Building Permit Application

PERMIT PLAN
WESTLAND FARM ESTATES
LOT 8
12541 WESTLAND COURT

From: Oswald, Hank <hoswald@howardcountymd.gov>
Sent: Monday, November 26, 2018 11:20 AM
To: Marina Morris <MarinaMorris@williamsburgllc.com>
Subject: Basement Floor Plan_12541 Westland Court_Lot 8

Drawing: FINISHED BASEMENT PLAN-1
Project: WILLIAMSBURG GROUP
THE RUTLEDGE
ESTATE HOME

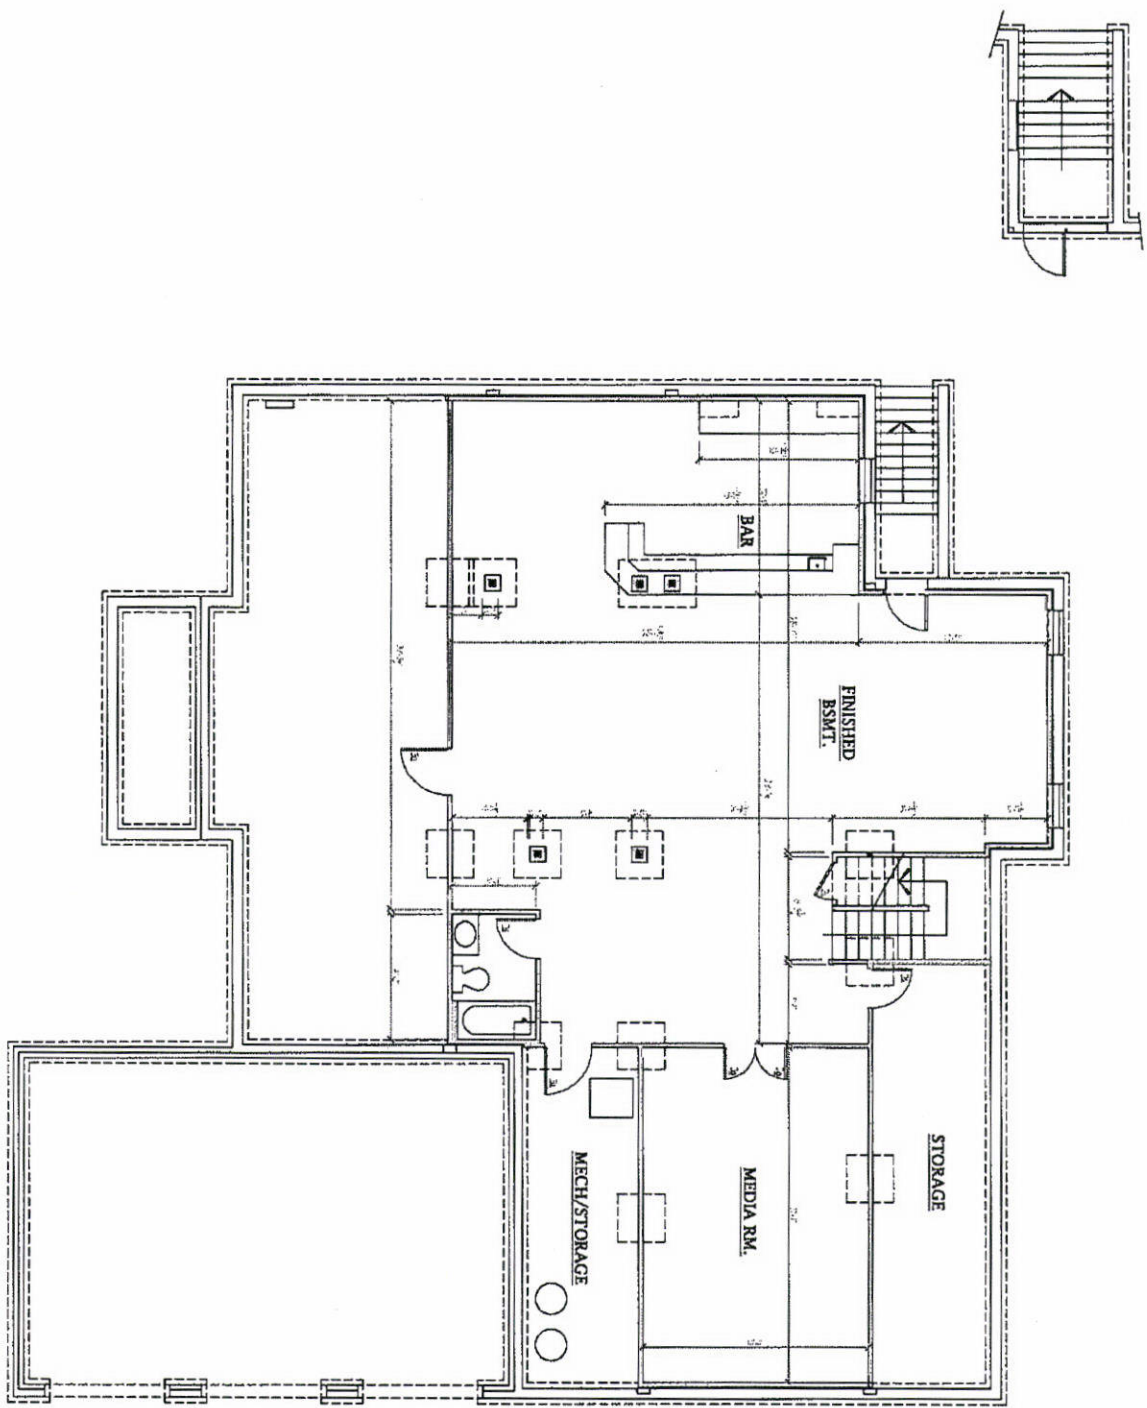
Please be advised that the request letter did not list the rooms that are being added in the finished basement, and the floor plan did not label all of the proposed rooms. I have attached a copy of the floor plan submitted, and highlighted the rooms shown and in question for your reference.

- Please provide a name for the large open room and clarify if there is a wet bar or kitchenette shown in this room.
- Please clarify if the three storage rooms are finished or unfinished.
